AS-BUILT

**GREENFIELD PARKWAY  
PHASE 1  
TYPICAL  
CROSS-SECTION**

1" = 2'  
NOVEMBER 12, 1997  
PROJECT: 97042  
15 of 34

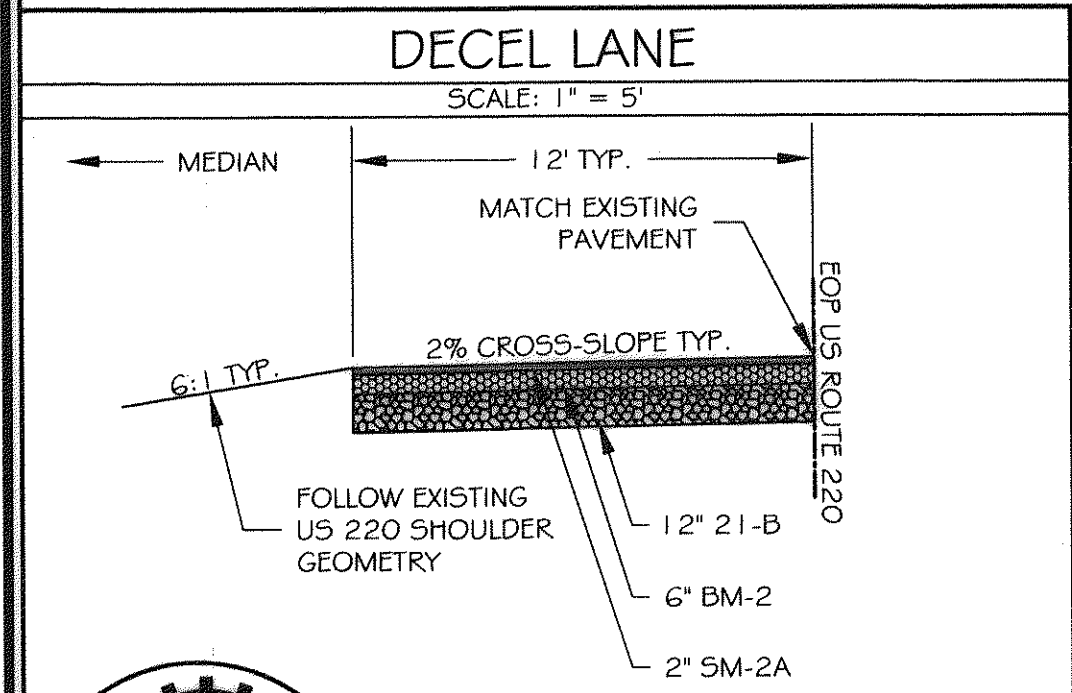
EXTEND 21-B BASE MINIMUM OF 1 FOOT BEYOND ASPHALT (TYPICAL)

ONE FOOT EXTENSION OF PAVEMENT TO BE TRANSITIONED BACK TO NORMAL WIDTH OVER 20'

MEDIAN TO BE VDOT MS-2.

SHOULDER SLOPE NOTE:  
SITE GRADING BASED ON 2% SLOPE.  
HOWEVER CONTRACTOR SHALL ADJUST SHOULDER SLOPES TO 5/8" PER FOOT.
